PSEG Public Service
Electric and Gas
Company

HOPE CREEK GENERATING STATION
DOCKET NO. 50-354
REVISED DSER OPEN ITEM/QUESTION RESPONSES/FSAR TEXT

DSER Open Item No. 250 (DSER Section 8.3.3.3.4)

Question 430.33DSER Open Item No. 260 (DSER Section 8.3.3.3.5)**THE USE OF A SINGLE BREAKER TRIPPED BY A LOCA SIGNAL AS AN ISOLATION DEVICE**

FIGURE 430.33-1 AMENDMENT 4, 1/84

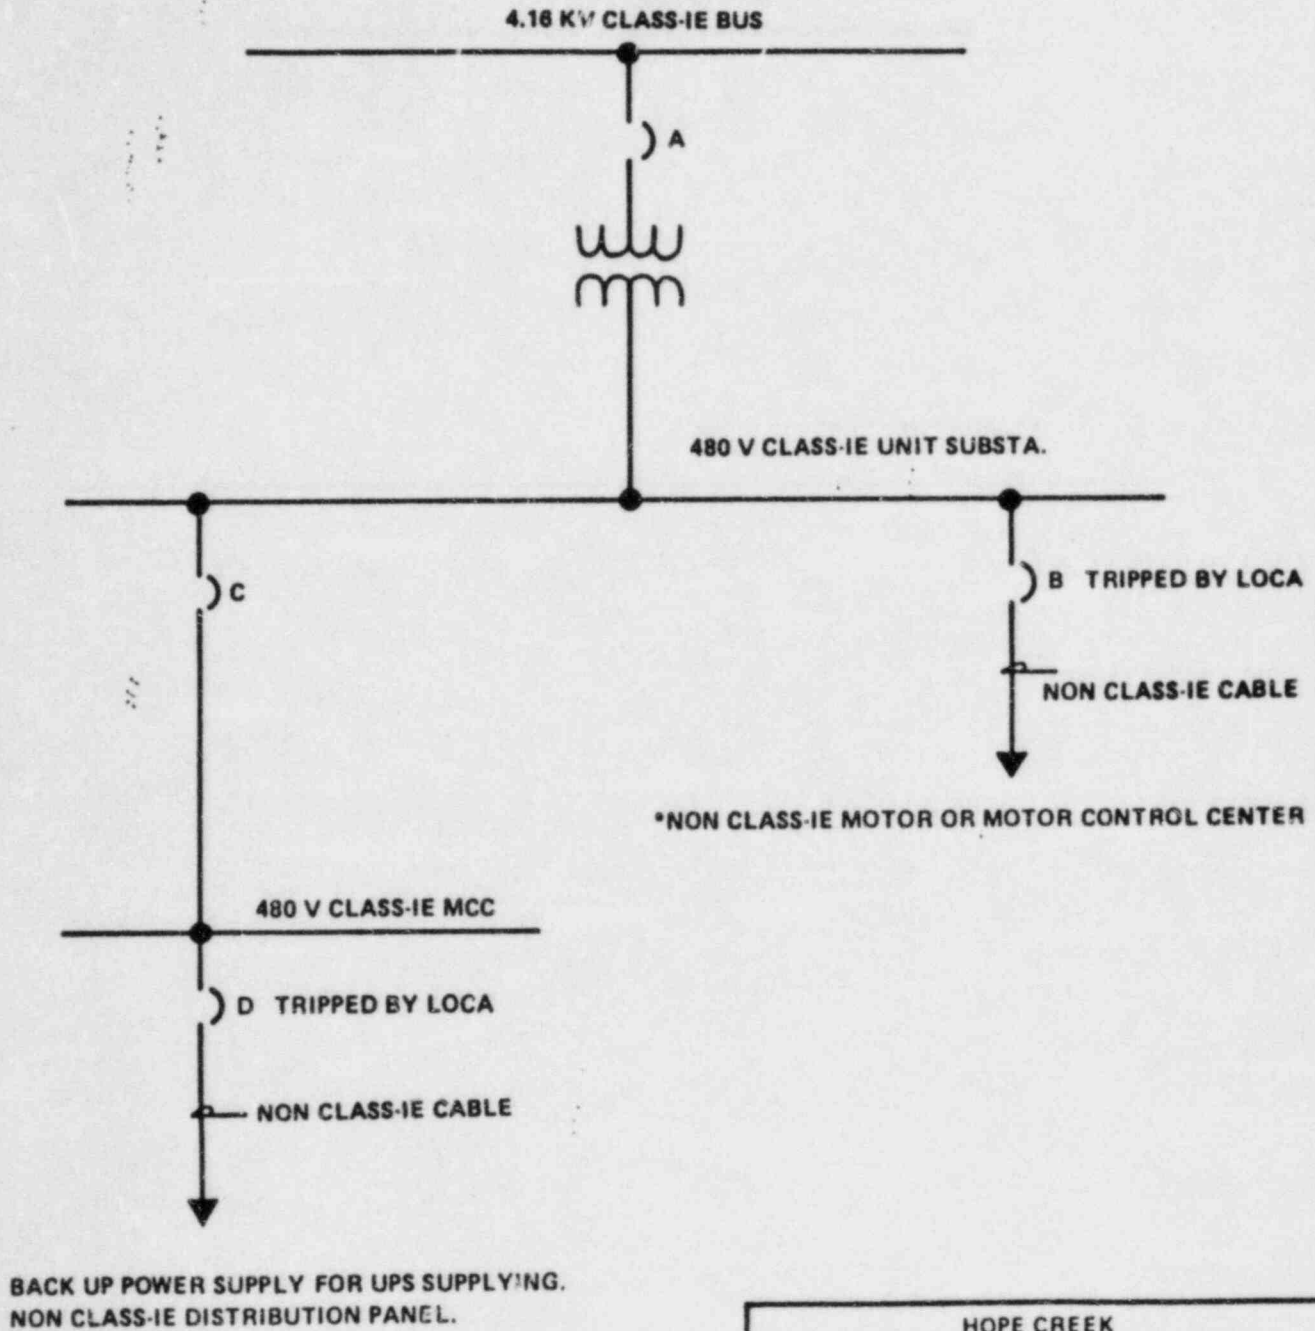
Section 8.3.1.1.2 of the FSAR indicates that the Class 1E system provides power to non-Class 1E loads. Non-Class 1E loads are connected to the Class 1E system through a single breaker that is tripped automatically by a LOCA signal. The single breaker tripped by a LOCA signal provides acceptable isolation between Class 1E and non-Class 1E circuits for the design basis accident--LOCA. However, for other design basis accidents or operating occurrences that do not generate a LOCA signal (such as loss of offsite power, design basis exposure fire, seismic events, etc.), it is the staff concern that a single breaker may not provide acceptable isolation.

By Amendment 4 to the FSAR, the applicant indicated that protective device coordination studies show that the single breaker time overcurrent trip characteristics will trip to clear a fault prior to initiation of a trip of a upstream breaker. Identification of all non-Class 1E circuits being isolated using a single breaker trip by LOCA signal, periodic testing of breaker coordination, and capability of breaker to trip prior to any versus only upstream breaker and for all versus only circuit faults, will be pursued with the applicant.

Section 8.3.1.1.2 of the FSAR indicates that the Class 1E system provides power to non-Class 1E loads. Non-Class 1E loads are connected to the Class 1E system through a single breaker that is tripped automatically by a LOCA signal. The single breaker tripped by a LOCA signal provides acceptable isolation between Class 1E and Non-Class 1E circuits for the design basis accident - LOCA. However, for other design basis accidents or operating occurrences that do not generate a LOCA signal (such as loss of offsite power, design basis exposure fire, seismic events, etc), it is the staff concern that a single breaker may not provide acceptable isolation. Provide an analysis, in accordance with the guidelines of Section 4.9 of IEEE Standard 308-1974, that demonstrates that failure of anyone or simultaneous combined failure of all non Class 1E loads will not prevent any of the four channels of Class 1E power from performing its safety function. The analysis should consider, but not be limited to, (1) capacity and capability of onsite and offsite power supplies and their associated distribution system to supply power to Class 1E loads within their design ratings for all modes of plant operation, (2) the guidelines of Section 7.1.2.1 of IEEE standard 384-1981, (3) an analysis of diesel generator loadings for loss of offsite power similar to that presented in Tables 8.3-2 through 8.3-6 of the FSAR, (4) the failure of the Non Class 1E dc system that supplies control power to the subject non Class 1E loads, and (5) a similar analysis of the Class 1E dc system if non-Class 1E loads are connected.

The following discussion demonstrates the adequacy of employing a single circuit breaker tripped by a LOCA signal as an isolation device between a Class 1E power bus and a non-Class 1E load for design basis event that do not generate LOCA signals.

Figure 430.33-1 shows the two configurations that employ a circuit breaker tripped by a LOCA signal as an isolation device. The two configurations are:

- a. A Class 1E unit substation supplies a non-Class 1E motor control center (MCC) or a motor load through Class 1E circuit breaker B.
- b. A Class 1E motor control center supplies through Class 1E circuit breaker D, a non-Class 1E distribution panel.

Protective device coordination studies for devices shown in Figure 430.33-1 have shown that the time-overcurrent trip characteristics of circuit breakers A, B, C, and D are such that:

- a. Circuit breaker B will trip to clear a fault current prior to initiation of a trip of circuit breaker A.
- b. Circuit breaker D will trip to clear a fault current prior to initiation of a trip of circuit breaker C.

Periodic testing of the breaker time-overcurrent trip characteristics will be performed to demonstrate that the circuit breaker trip function remains within required limits. Table 430.33-1 identifies the non-Class 1E loads that are supplied through circuit breakers B and D of Figure 430.33-1.
